RE: DA/1157/2016/H & DA/295/2020 – Applicant’s Contested Conditions Letter dated 19 November 2020

MELROSE PARK - VICTORIA ROAD

SITE - Lot AB STAGE
4 DA 16012

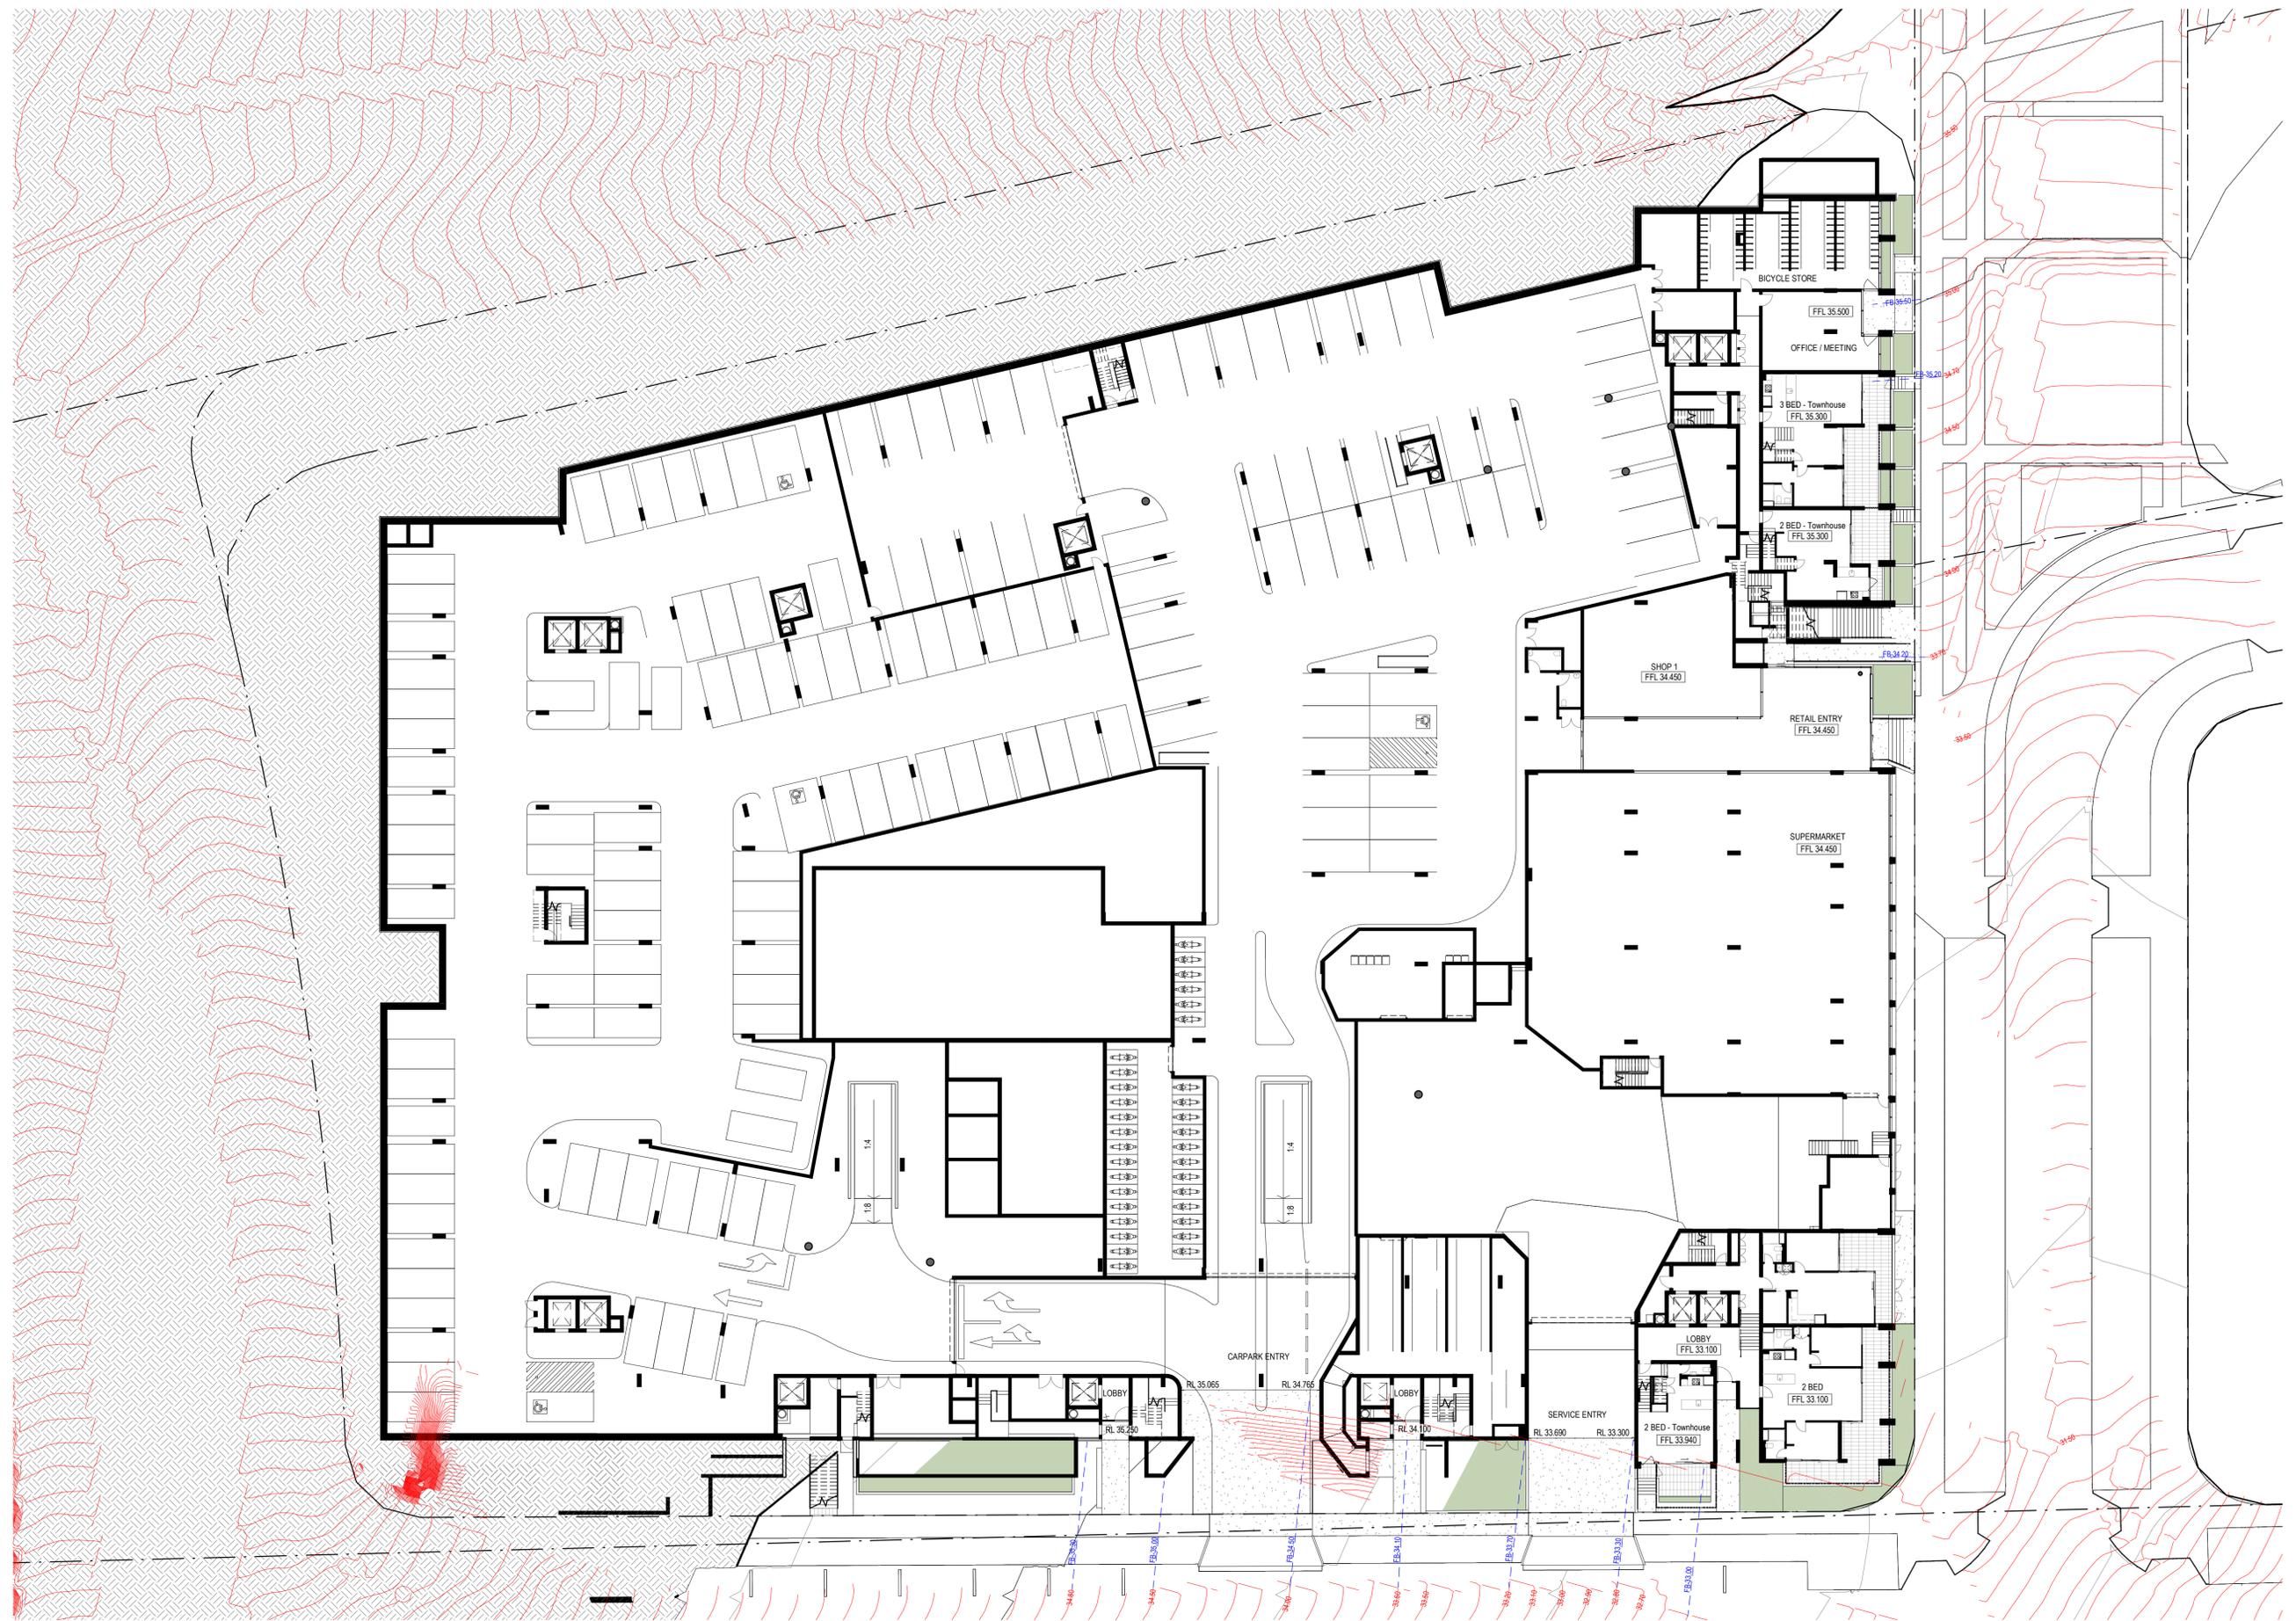
58	Modify 500mm to 300mm	<p>DESIGN TO WITHSTAND FLOODING</p> <p>The building must be designed and certified by a registered structural engineer to ensure the building does not fail due to floodwater forces, debris and buoyancy effects from flooding events up to the 1 in 100 year level plus 500mm freeboard.</p> <p>Reason: To ensure the structure can withstand flooding impacts.</p>	<ul style="list-style-type: none"> • During assessment, the applicant submitted, as requested, flood contour diagrams demonstrating that the proposal does achieve the 500mm freeboard requirements (see attached). As such, it is not clear why the applicant seeks to reduce the freeboard requirement. • Regardless, the freeboard is the only safety factor that applies to flood risk management. Council universally applies a 0.5m freeboard across the whole LGA for every flood affected development, at every scale, from minor home additions to precinct scale developments such as Parramatta Square. This proposed variation would be unique.

59	Modify 500mm to 300mm	<p>FLOOR LEVELS</p> <p>The finished floor levels of all habitable rooms/floors including but not limited to residential and commercial uses shall be a minimum of 0.5m above the 1% AEP overland flow water surface level in the adjacent roads assuming 100% blockage of the piped road drainage system as modelled by Lyall Associates October 2020. These minimum finished floor levels shall be in accordance with drawing SK120 'Level 1 Flood Contours' and SK 121 'Levels 2-3 Flood Contours' by AJ+C filed by Council on 26.10.2020 under D07716655. If the finished floor levels shown on drawings SK 120 and SK 121 are higher than those shown on other architectural drawings at the same location, the levels on SK 120 and SK 121 shall take precedence.</p> <p>Details demonstrating compliance are to be submitted to the satisfaction of the Certifying Authority prior to the issue of the relevant Construction Certificate(s).</p> <p>Reason: To ensure adequate protection of life and property from flooding.</p>	<ul style="list-style-type: none"> • The 0.5m freeboard is recognised and mentioned in the NSW Government's Flood Plain Development Manual several times, notably in Section K regarding determining the Flood Planning Level. The Manual is the most important guideline for Councils in flood risk management and following the Manual protects Council and other determining bodies from liability under the Local Government Act. • As noted by the Manual, reducing flood freeboard transfers costs and risks from the developer to future landowners and occupants and is therefore an equity issue. • Freeboard provides the only safety factor for a number of other unquantifiable but real factors including: inherent inaccuracy of flood modelling, local variations in water levels from waves, currents and turbulence, vehicle wake, unmodelled new development in the catchment, and climate change. • As a result the 0.5m freeboard is universally applied by Council and variations to this are not supported. • As such it is recommended that conditions 58 and 59 remain as proposed.
